# Change Notice

# AT Accessories

## Changes to AT4001, AT4002, AT4011 and AT4145 Dust Covers

<b>AT4001 Square Dust Cover</b> For Series LB & UB	<b>AT4002 Round Dust Cover</b> For Series LB	<b>AT4011 Rectangular Dust Cover</b> For Series LB & UB	<b>AT4145 Square Dust Cover</b> For Series UB2
---	---	--	---

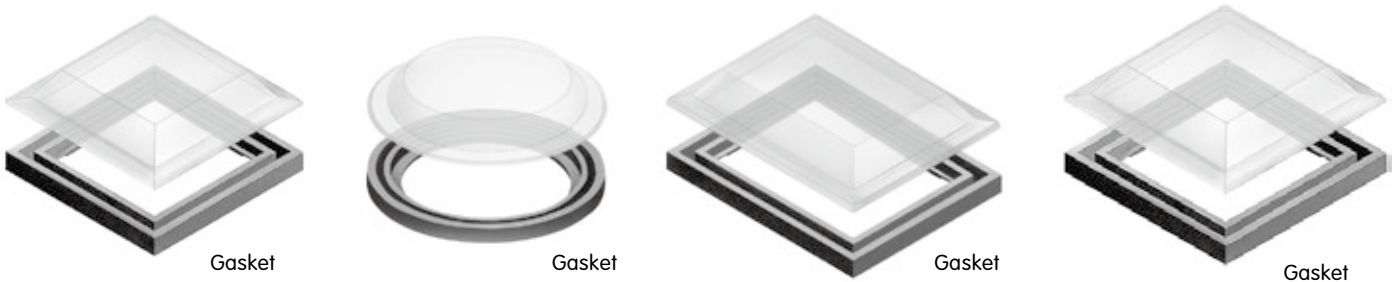
There will be revisions to the material used in the gaskets for AT4001, AT4002, AT4011 and AT4145 Dust Covers. The material is converting from High Density Polyethylene (HDPE) to Low Density Polyethylene (LDPE). The change will effect all four of the gaskets for standard or custom dust covers, but will not alter their quality or performance. The accessories below are identified with their standard part numbers as well as with the series in which they are used: LB, UB and UB2, for both illuminated and nonilluminated models in the series.

Gasket Material	
Before Change	After Change
High Density Polyethylene (HDPE)	Low Density Polyethylene (LDPE)

There are no changes to any of the dust covers' or gaskets' dimensions. Contact information is below if more details are needed.
